Ref : G1525/CS/L913/HyD Date : 16 January 2019

Contract No. HY/2011/08 Central – Wanchai Bypass- Tunnel Building, Systems and Fittings and Works Associated with Tunnel Commissioning

APS Commissioning Test Report Under Condition 2.8 of EP-482/2013/A

Photo 6

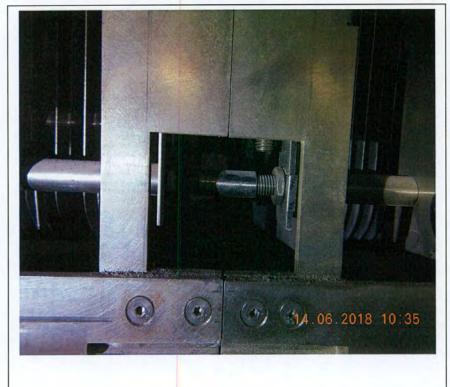
Hexagon type connection bolts for interconnection between module to module should be used, please replace

Photo 8

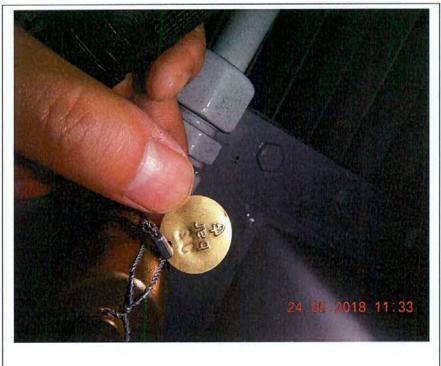
Refer to material latest submission of DC generator, model of HVT for ionizer is DSO 38-24/2503, please replace equipment tag
